Final Report

Little Thompson River Hydrologic Analysis

Phase 2: Little Thompson River above
Big Thompson River

Prepared for
Colorado Department of Transportation

FIGURE ES-1
Little Thompson Overview Map

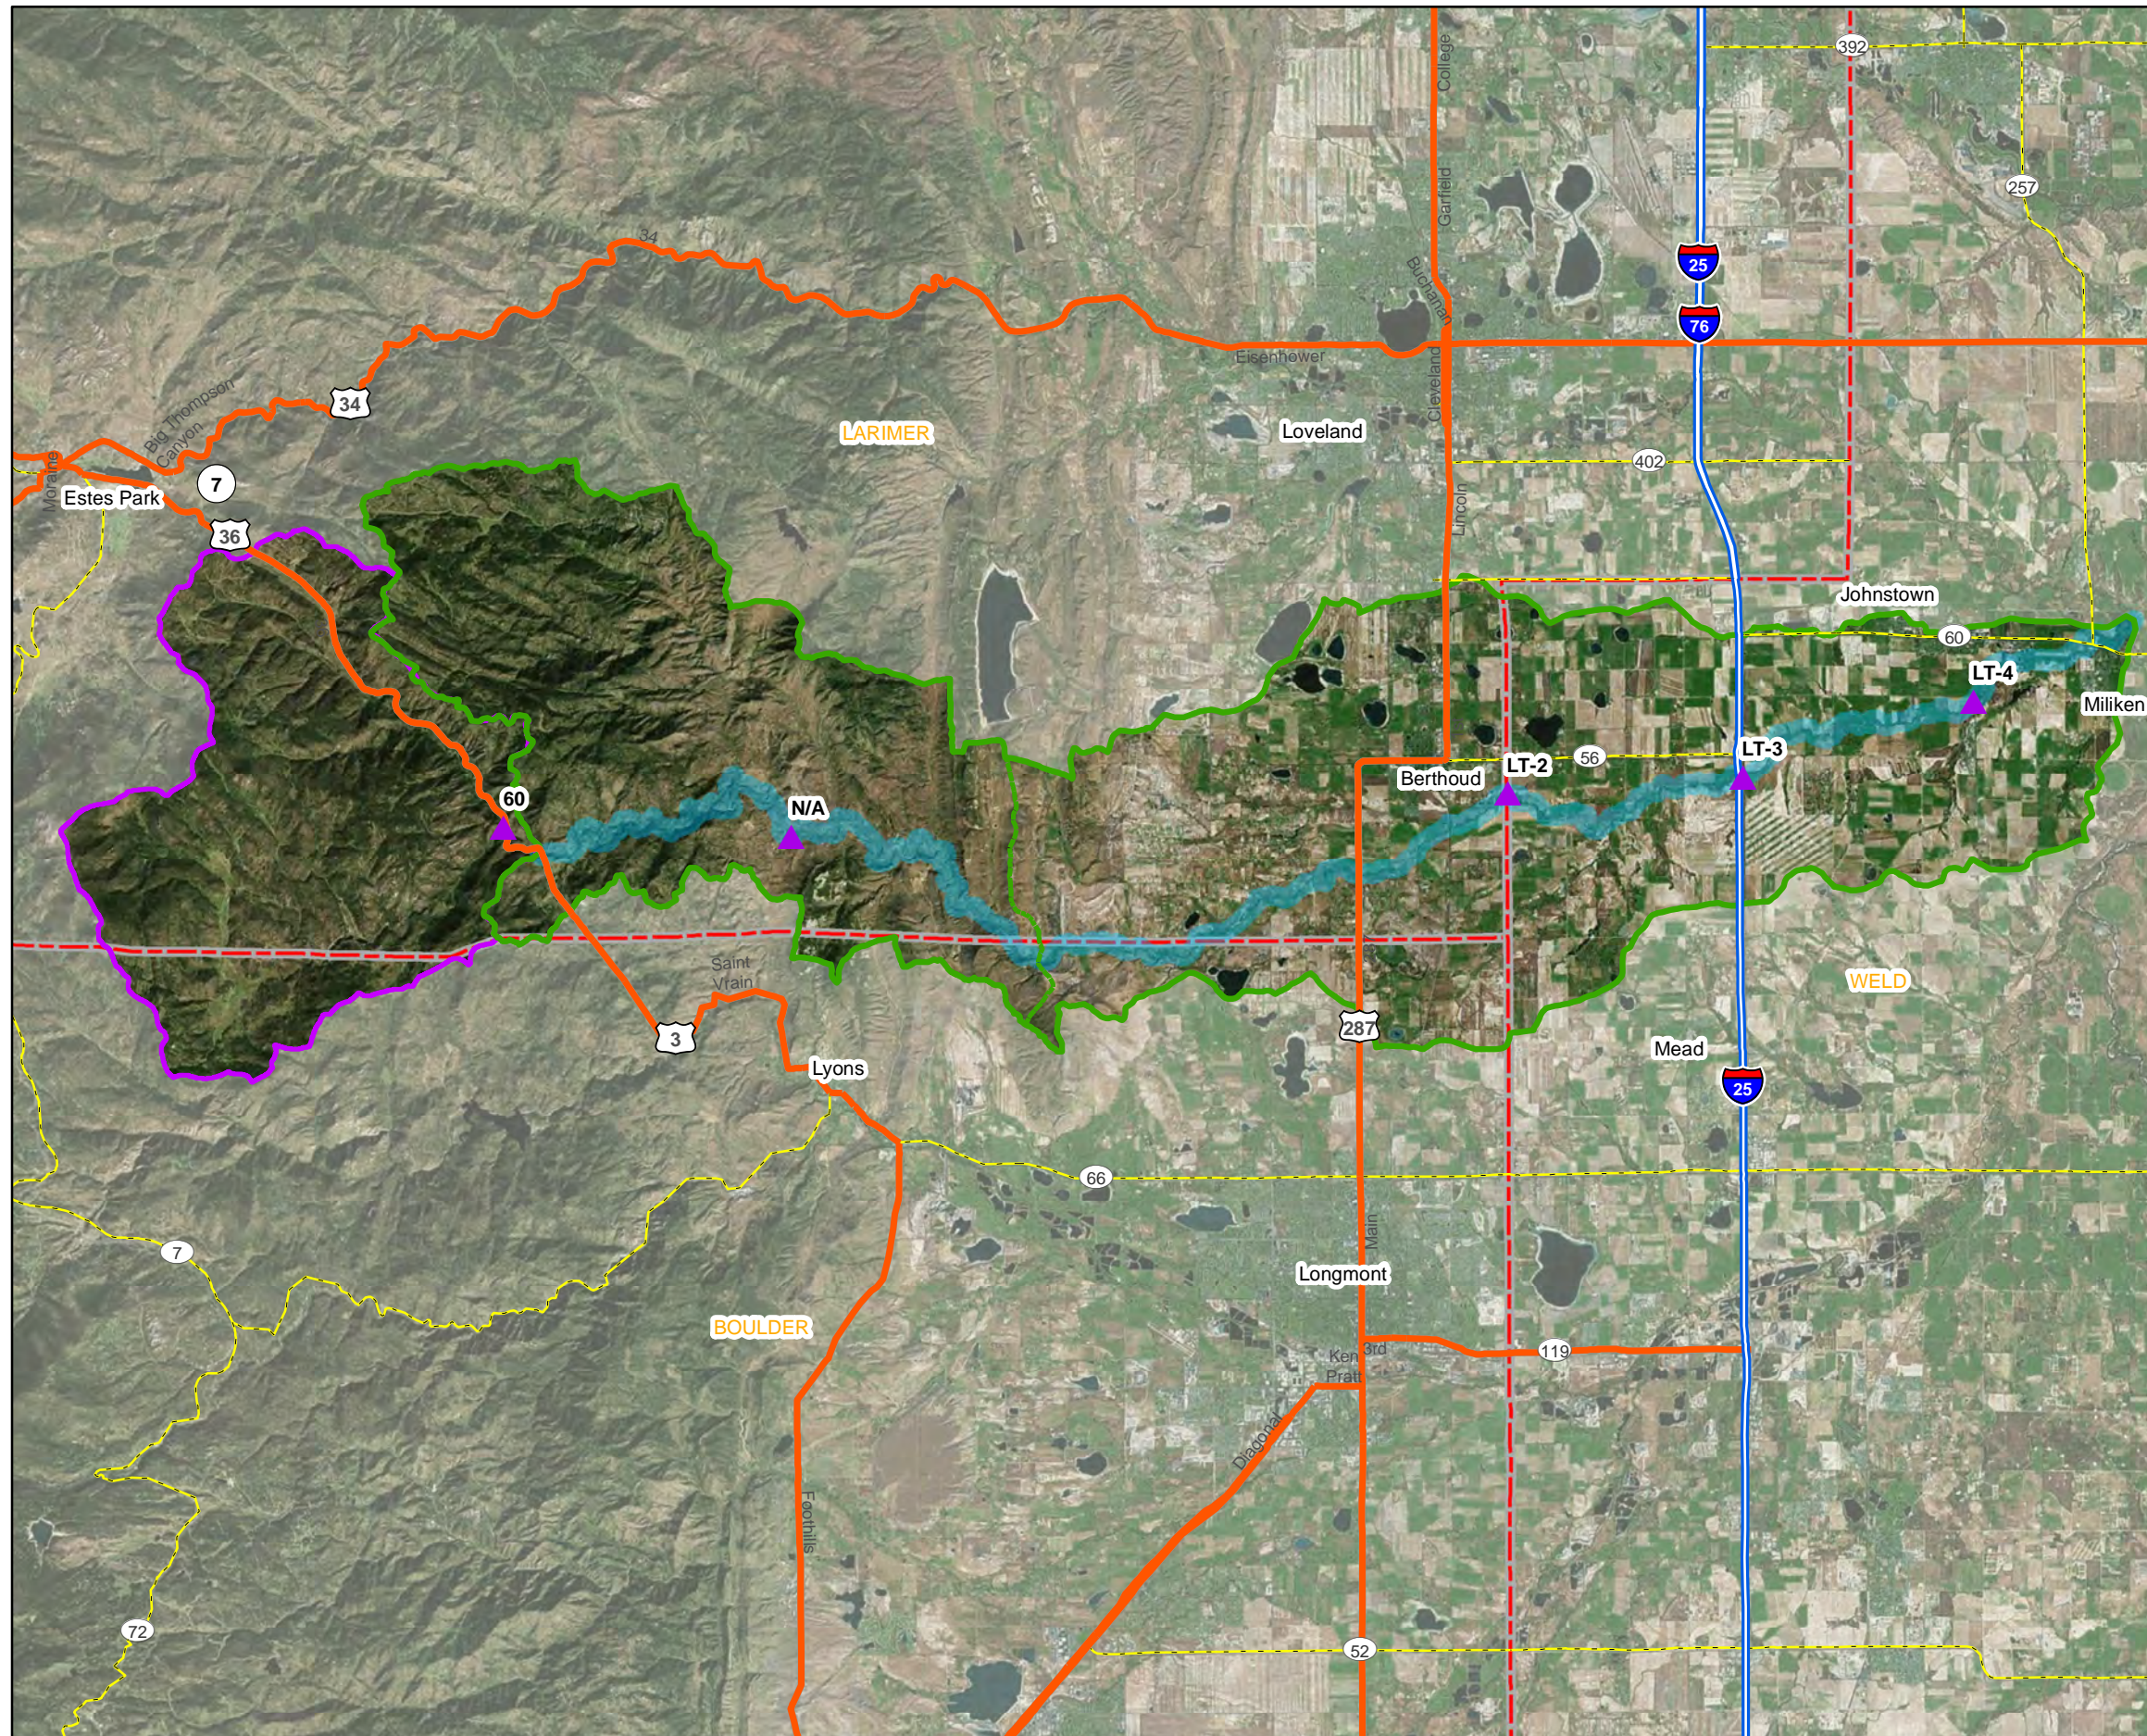
1. **Comment:** ES: Figure ES-1 is included in the Executive Summary, but I believe that the actual reference for it was missed. Providing that before referencing Table ES-1 may help the reader better understand where the discharge points in Table ES-1 are located.

Response: A reference to Figure ES-1 was added to the text before referencing Table ES-1.
2. **Comment:** Section 1.2: there is some discussion of the overall Little Thompson watershed, but the description refers only to the study area portion of the watershed. For example: the report states that the watershed is located in Larimer and Boulder County. In reality, it is also located in Weld County too. I would recommend some small changes to clarify whether it is referring to the entire watershed or only the study area. Along those same lines in the same section, it states that there are no regulatory flow rates published for the river. To clarify, that statement is true only for the study area portion of the river.

Figure ES-2 - Little Thompson River Peak Discharge Profiles

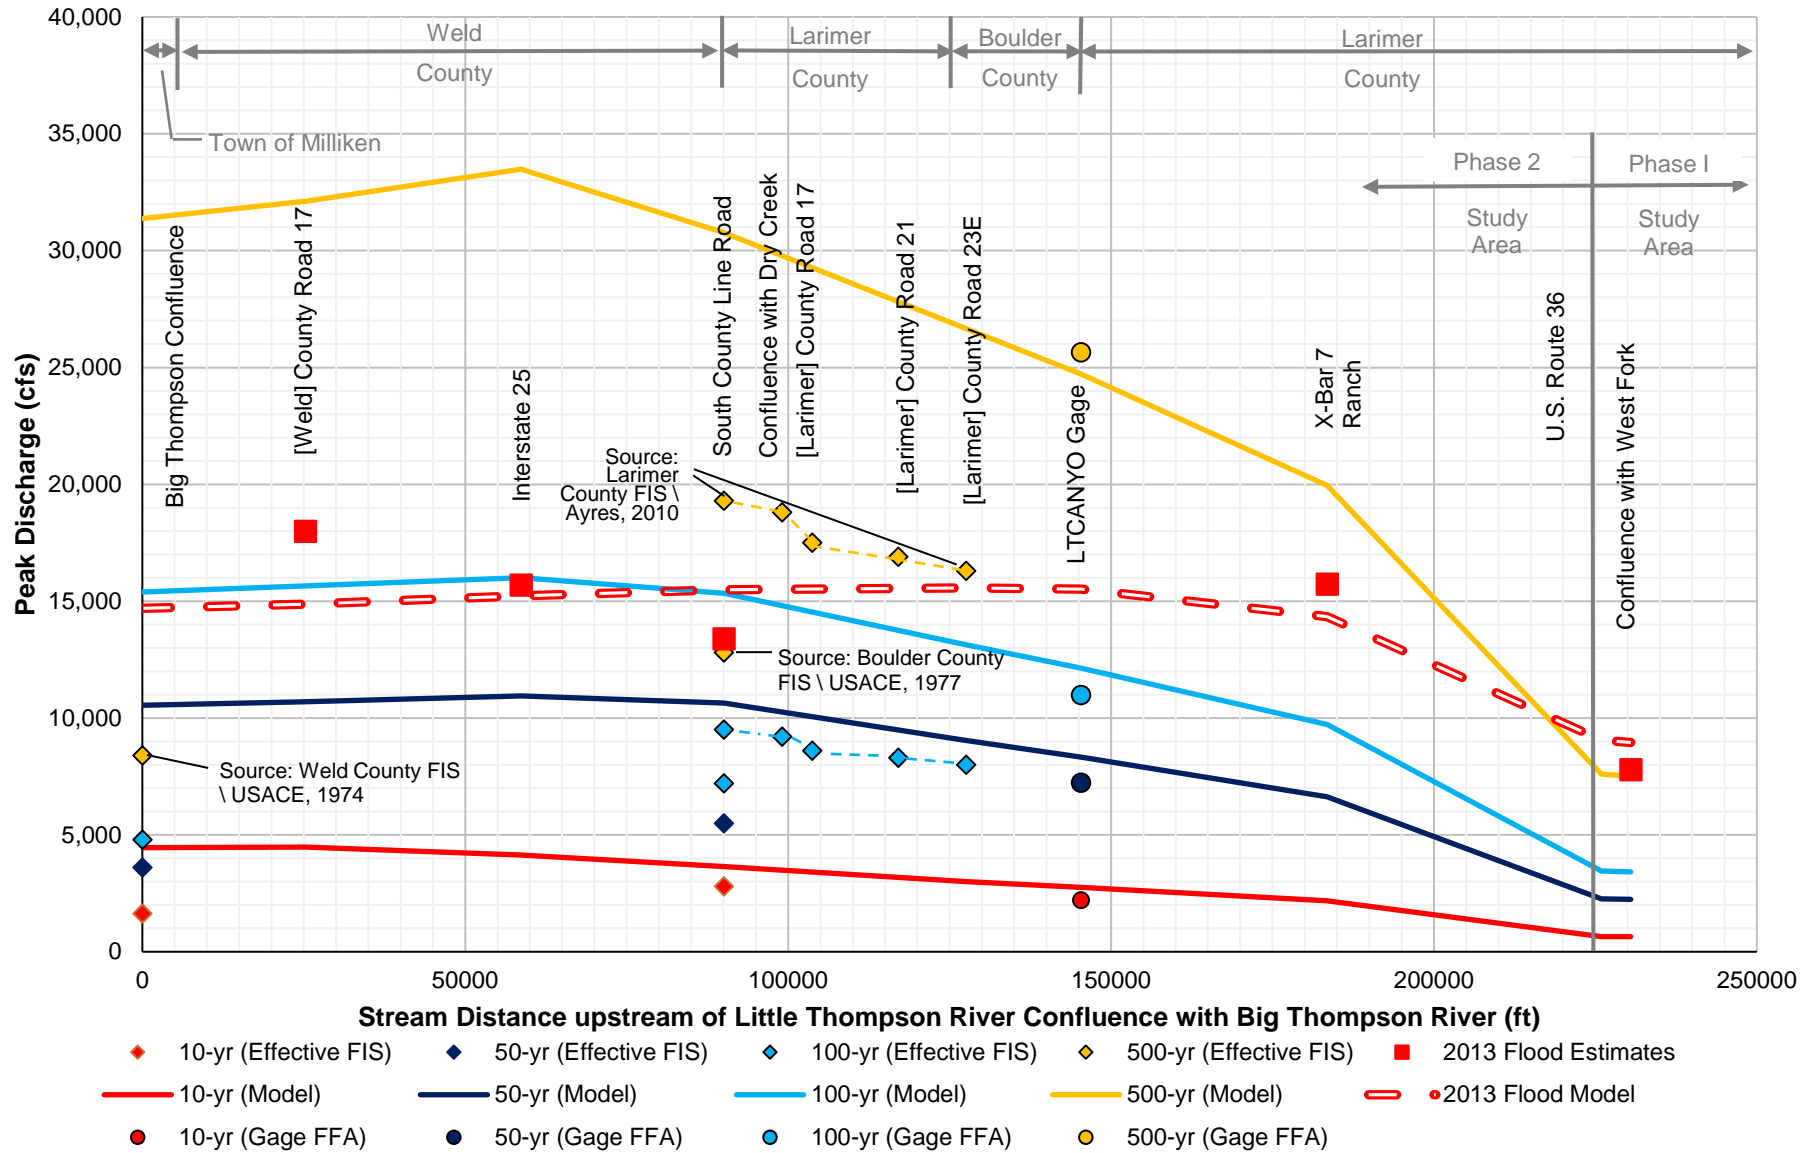
15. **Comment:** Figure ES-2: Flipping the x axis to show distance downstream of initial estimate makes more sense.
Response: *Peak discharge profiles were developed to be consistent with Flood Profiles presented in FEMA Flood Insurance Studies; this includes the orientation of the X axis.*

Figure 4 – Phase 2 AWA 10 Day Precipitation

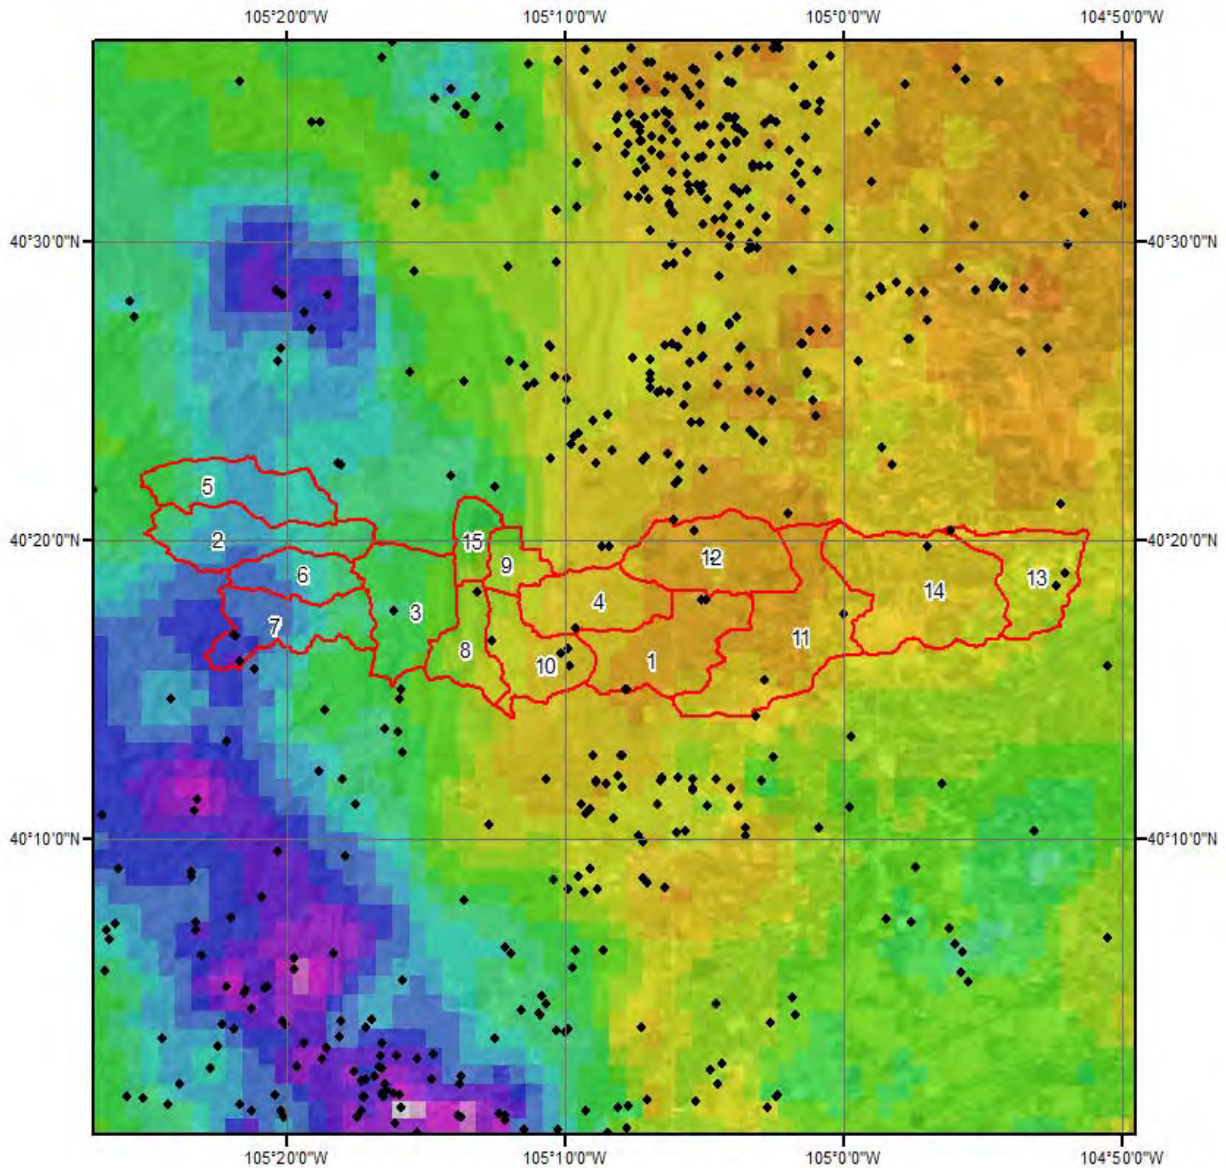
10. **Comment:** Page 2-9 – Figure 4 is supposed to provide the various DARF curves but Figure 4 actually provides the Phase 2 AWA 10-day precipitation. The DARF curves are only given in the AWA report.

Figure 14 - 1 Percent Annual Chance Peak Unit Discharge vs. Subbasin Area

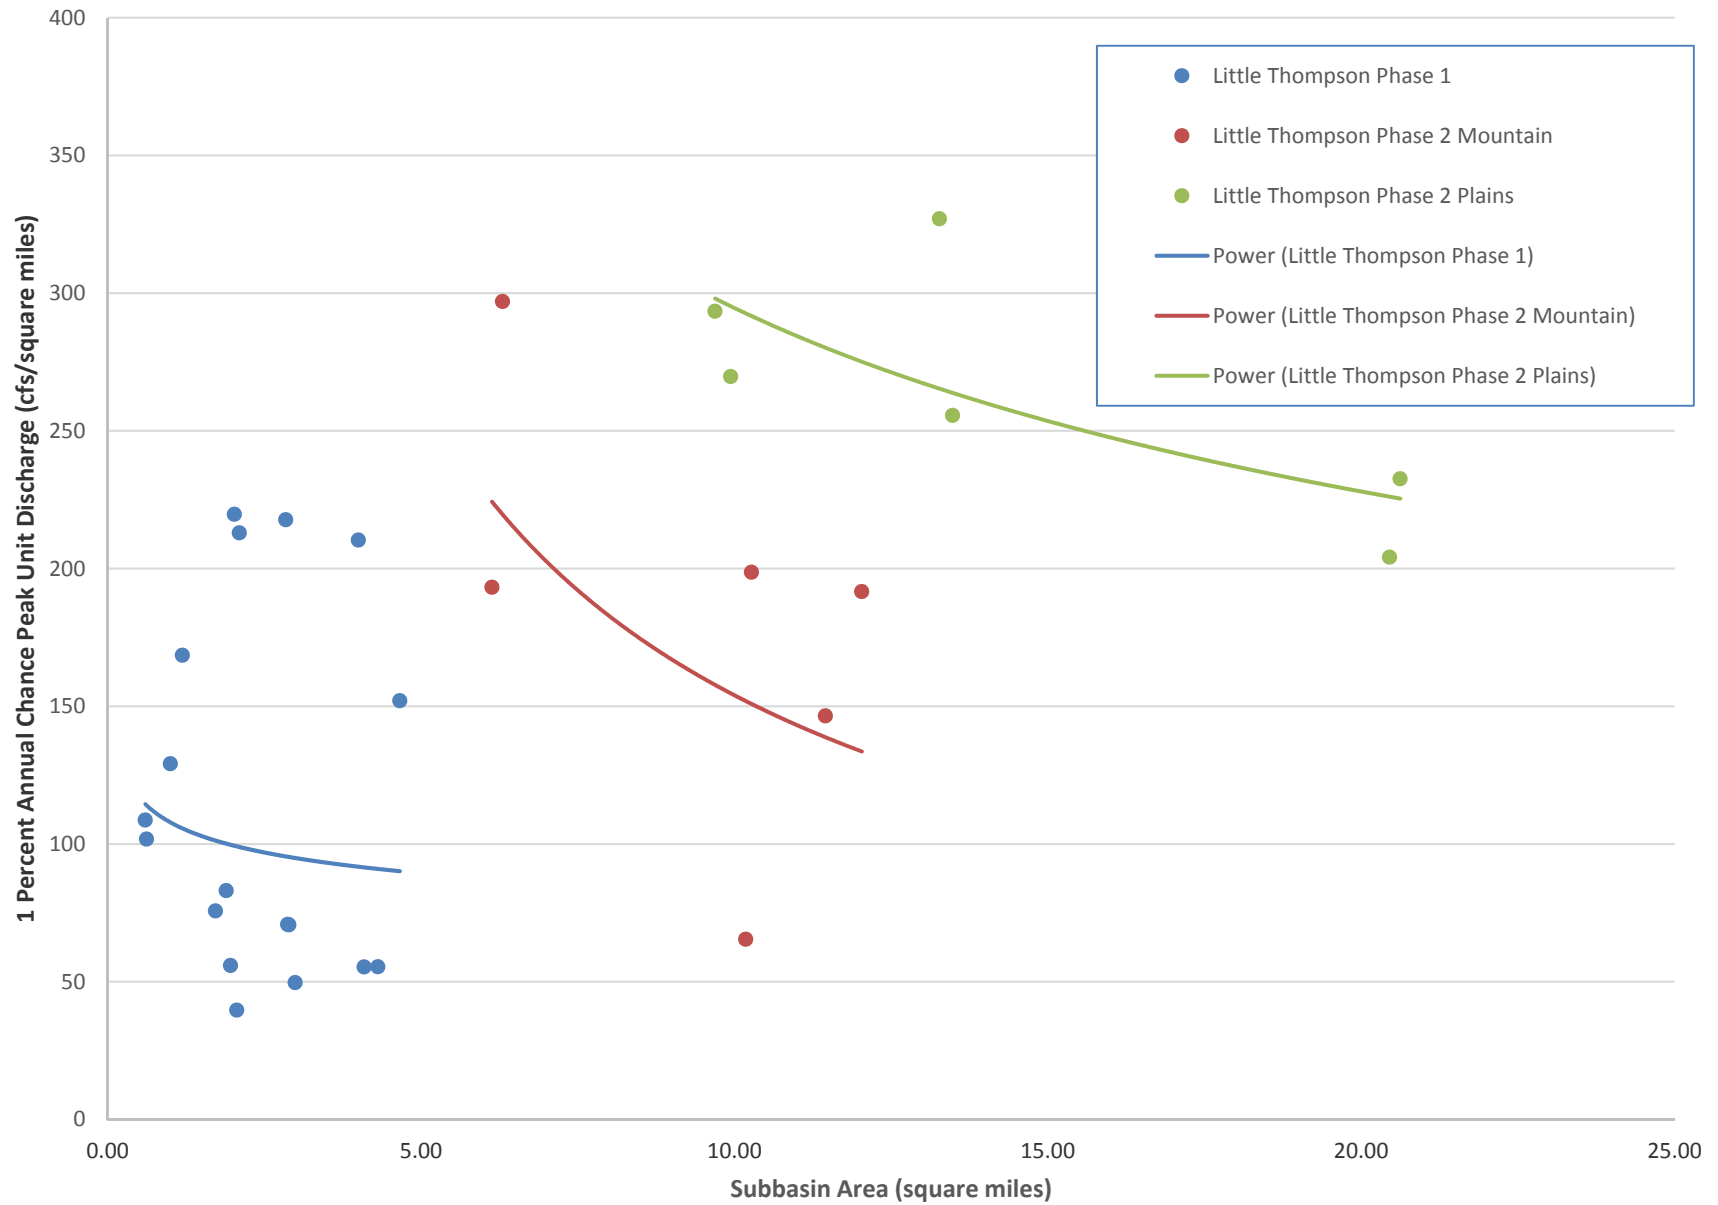
6. **Comment:** Section 3.1 (Figure B-14): To provide comparison and additional validation of the results, it would be good to add data from similarly sized, nearby basins (assuming similar characteristics) that have measured streamflow data from which 1-percent peak flows have been computed (if the data exists).

13. **Comment:** Page 3-1 – There is the statement “Little Thompson River Phase 2 Mountains and Plains have higher discharge than Little Thompson Phase 1 due to higher peaking coefficients and higher CNs due to increased urbanization.” The reference is to Figure 13 that shows 1-percent chance discharges versus drainage area. The 1-percent chance discharges are, of course, higher in the Phase 2 study because of the large increase in drainage area. I think the implication is that the 1-percent chance discharges are higher even when considering the increased drainage area. The quoted statement should be clarified.

Response: The 1-percent peak flows per drainage area for Boulder Creek have been added to Figure B-14 for comparison. This report has been referenced for the reader. The values are in a similar range as Little Thompson River and West Fork Little Thompson River from approximately 25 to 150 cfs /square mile for subbasins sized from approximately 0.5 to 5 square miles.

Response: *This statement concerns Figure 14, not Figure 13. The reference has been updated and the statement has been moved to a location following the reference about Figure 14 - 1 Percent Annual Chance Peak Unit Discharge vs. Subbasin Area.*
